**EXTINGUISH THE TORCH MEETING
SESSION ONE**

FIN: 429331-1-52-01 & 429332-1-52-01
Contract No.: E8M50
Description: SR 91 and I-4 Inter. Improvements Project
Contractor: Middlesex Corporation
Project Acceptance Date: Oct. 21, 2014
County: Orange

SR 91 (Turnpike) and I-4 Interchange Improvements Project Design/Build
FPN's 429331-1-52-01 / 429332-1-52-01
Contract No. E8M50

FIGURE 1
 SITE PLAN
 (SOIL EXCAVATION PLAN)

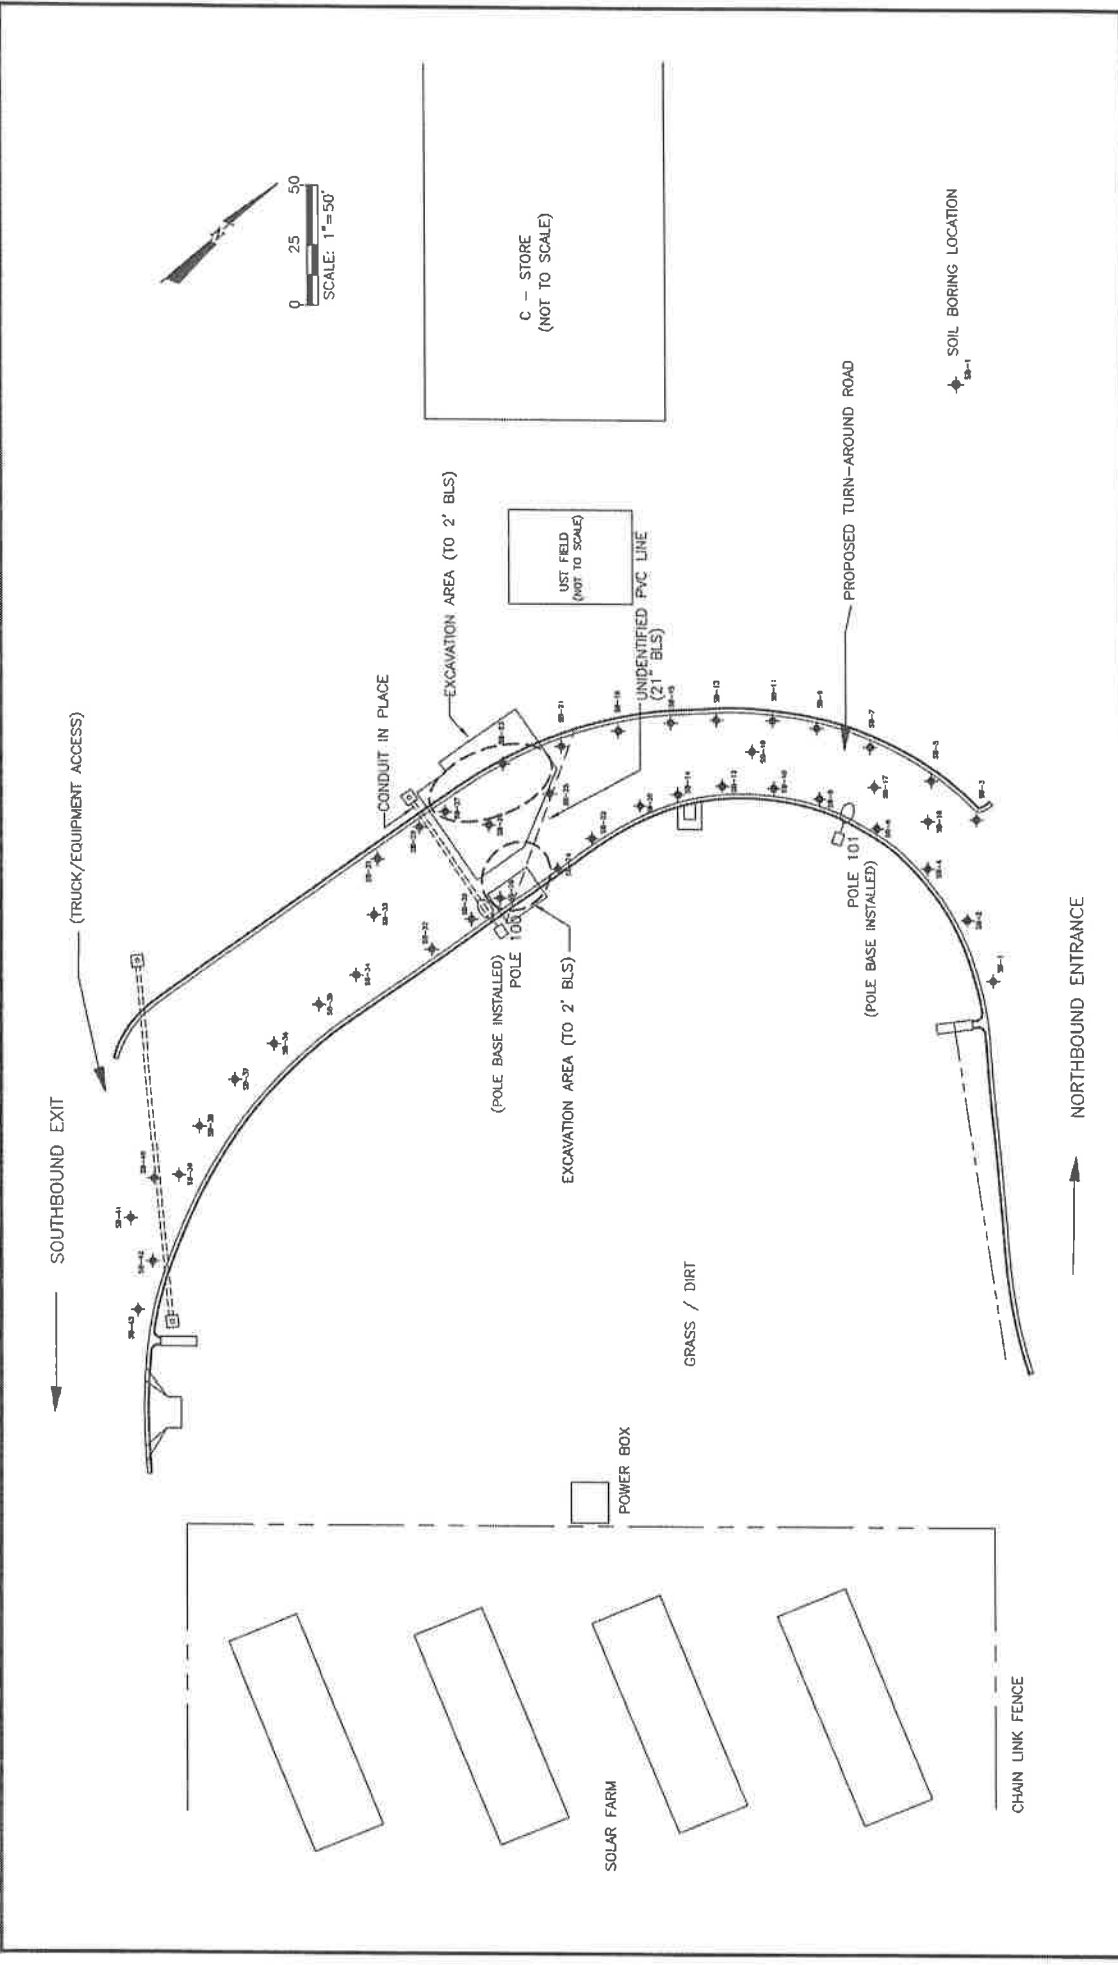
During the construction of the Turkey Lake tandem truck turnaround high concentrations of hazardous material vapors were encountered. Construction activities were suspended until a hazard assessment could be performed and solution derived.

CEI called in the Turnpike EMO office to sample and verify the limits of hazardous material. Initially the contractor told us they would only be removing two feet of material so only that strata of material was tested. It was later determined that the two feet of material to be removed was actually two feet below final proposed elevation which was deeper than existing elevation. The environmentalists had to return, test and remove additional material. A miscommunication as to the reference point for the depth of the material to be removed slowed progress on the tandem truck turn around but did not affect the critical path activities.

Additionally a Work Order was executed to provide extra depth limerock base in lieu of the proposed type B stabilization. This change limited the depth of hazardous material removal and eliminated mixing the underlying soils. Cost of the extra work \$11,270.03.

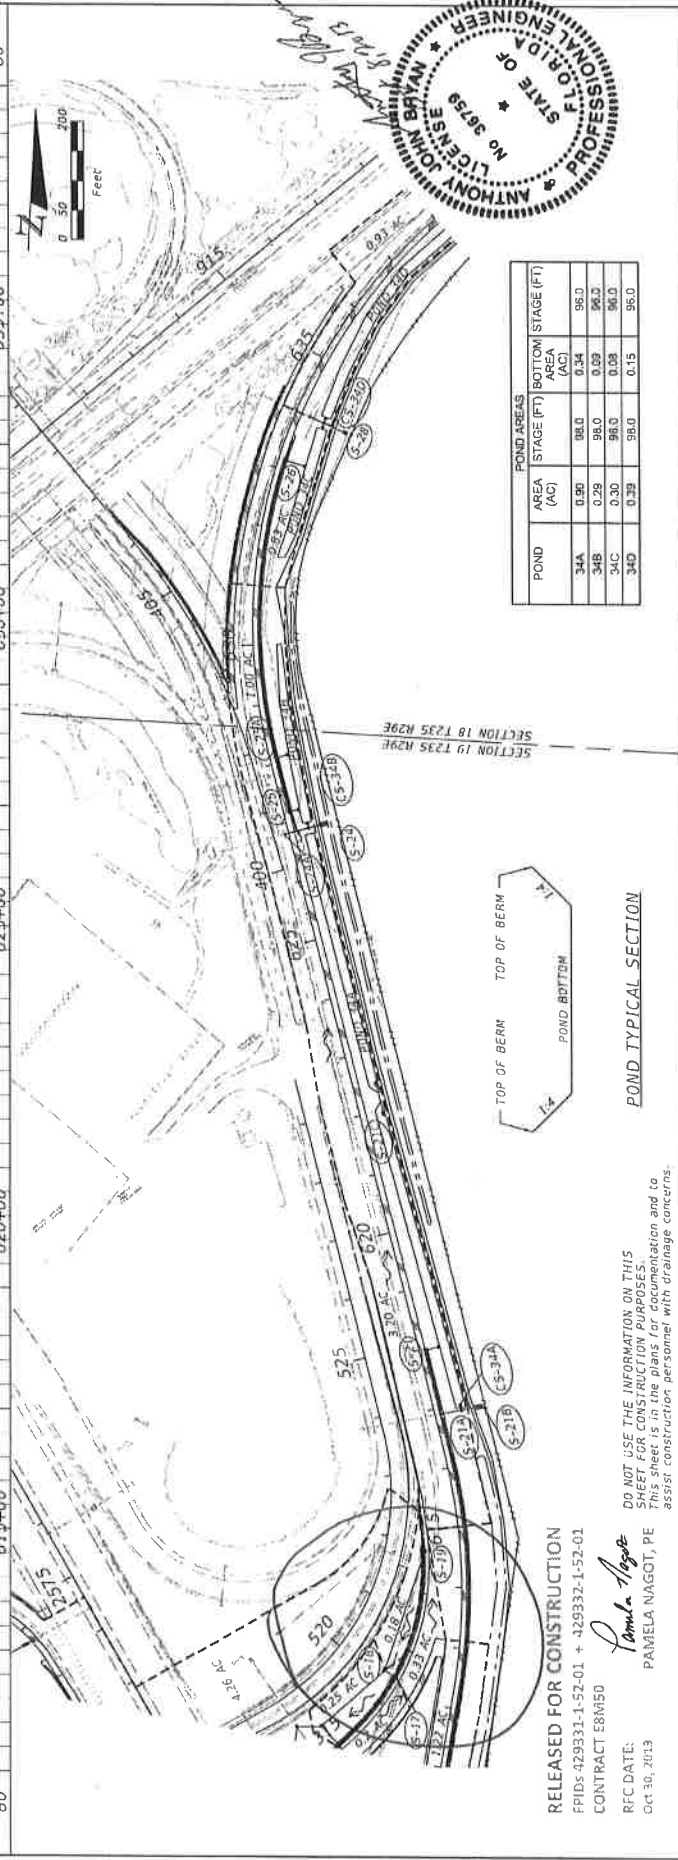
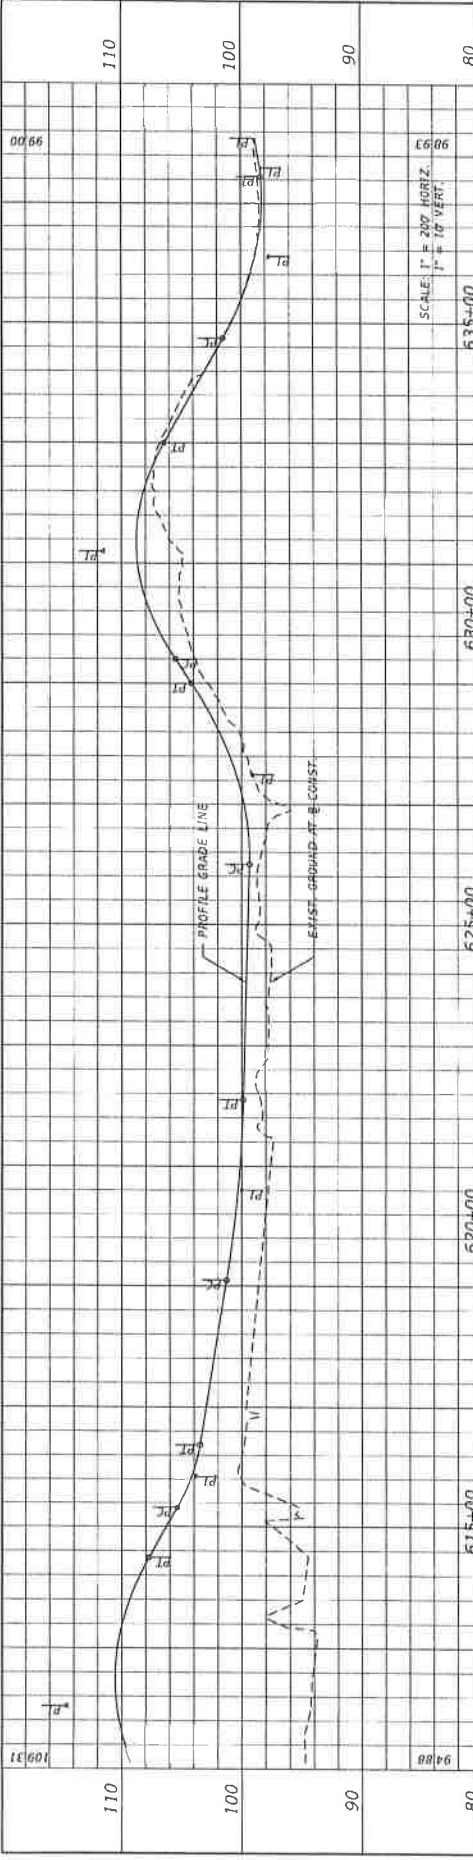
7	P-04	2560+20 to 2563	Varies RT	24" and 26" FGT GM	STEEL	Ditch 30, Adjacent Ditch near Ditch 30, Guardrail	X	11/15/13. Following a site visit on 11/14/13, FGT will allow the existing site work to remain and approve the Ditch 30 as it is today. Submit revised plans sheets and cross sections with corrected pipeline elevations for FGT record approval. 11/17/13. Please proceed with the design resolution and provide revised plan sheets for the exception review. No reduction of cover or removal of soil with 30' from centerline of the 24" and 26" FGT transmission pipeline easement	The existing ditch bottom elevation was permitted in 2004 under Permit 48-01443-P. The proposed ditch bottom is the same elevation and provides conveyance and floodplain compensation. To accommodate FGT, the ditch can be shifted towards the R/W but will remain partially within the easement. Note there is no reduction of cover over the FGT mains. NOTE: TMC HAS REQUESTED EXCEPTION FROM FGT

9	P-04	2567 to 2570	Varies RT	24" and 26" FGT GM	STEEL	Pond 30	X	11/17/13. Please provide revised plan sheets for FGT final review and comment. Show FGT pipelines in Pond Cross Sections	Include FGT 24" and 26" pipelines in pond cross sections.

14	P-08	2570 to 2571		Varies RT	24" and 26" FGT GM	STEEL	24" Drainage Pipe and Mitered End Section by Pond 30		11/1/13, Either Option appears to resolve the conflict, please provide revised plan sheets for FGT final review and comment. Move the Drainage Pipe and Mitered End Section to outside of 30' from centerline of the 24" and 26" FGT transmission pipeline easement	Option 1: The pond can be reshaped to allow outfall near MSE wall and not cross FGT mains. Option 2: MSE wall can be redesigned to accommodate pipe thru wall at elevation 93.9 and tie pond contours to wall.
15	P-08	2570 to 2570+40		Varies RT	24" and 26" FGT GM	STEEL	Pond 30	X	11/1/13, Please provide revised plan sheets for FGT final review and comment. Show FGT pipelines in Pond Cross Sections	Include FGT 24" and 26" pipelines in pond cross sections.
16	P-08	2568		Varies RT	24" and 26" FGT GM	STEEL	Mitered End Section	X	11/1/13, Please provide revised plan sheets for FGT final review and comment. Move the Mitered End Section to outside of 30' from centerline of the 24" and 26" FGT transmission pipeline easement	Outfall and pond contours will be reshaped to accommodate easement. MES will be changed to U-Type Endwall.

FROM TMC BASED UPON 10/25 FIELD REVIEW WITH FGT:										
19	S-5	2557+60		Varies RT	24" and 26" FGT GM	STEEL	Overhead Cantilever Sign Structure Support and Foundation, (1) Single Post Sign	X	<p>This sign appears to be outside to FGT easement area. Confirm or move Sign to outside of 30' from centerline of the 24" and 26" FGT transmission pipeline easement</p> <p>11/11/13, Please provide revised plan sheets for FGT final review and comment. These signs will be considered a readily removable structure that FGT will approve within the specified width of the FGT Easement. Please shift these signs further away from the FGT pipelines</p>	<p>FGT Conflict No. 19 – Overhead Cantilever – 24" gas line was located by FGT and based on a 15' offset between pipes we measured 32'-10" from FGT centerline to center of shaft, on 30'-4" to back face of the drilled shaft. It has been confirmed that this location will not require revision to current design.</p> <p>SAB RESPONSE - These signs will be shifted away from the FGT lines to the extent feasible</p>

11/15/13. Following a site visit on 11/14/13 it was determined that the elevation of the 26" FGT pipeline was shown incorrectly on the typical cross sections for Ramp K which caused the cuts for the stabilization work to be within 14" of the 26" pipeline. After completing the wheel load calculations for the proposed equipment crossings, it was determined that FGT will only allow the cuts over the pipeline to be removed by an excavator placed away from the pipeline and only using a toothless bucket. The 12" stabilization layer will be compacted using only a walk behind compactor. Only after the installation of the first four inch (4") lift of subbase material (limerock) will FGT allow the Roller (CAT 355E) to operate in "Static Mode" over the FGT pipeline. No vibratory rollers will be allowed to be used over the pipelines, all compaction will be achieved in static mode and will be required for all compaction activities being proposed within 10' from the outside of the FGT pipelines. Submit revised plans sheets and cross sections with corrected pipeline elevations for FGT record approval.

SHEET NO. XS-32

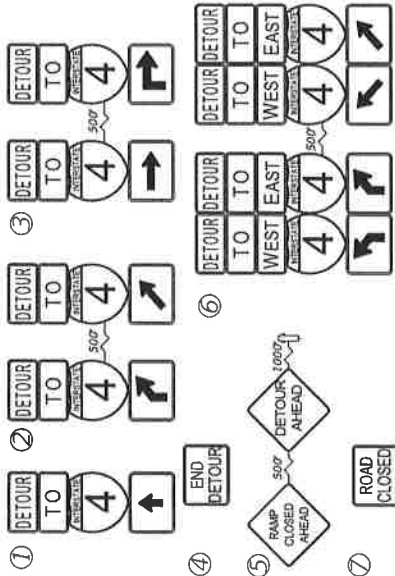
The traffic control plan did not address the MOT at the tie to the connector road where ramp C and Ramp K merge. The reported 7 inches of overbuild at the Technical Proposal stage became 16 inches in final design.

It was determined that because of the thickness of the asphalt and drop off conditions both Ramp K and Ramp C traffic NB would have to be detoured to allow enough time to construct the overbuild and place traffic back on safely.
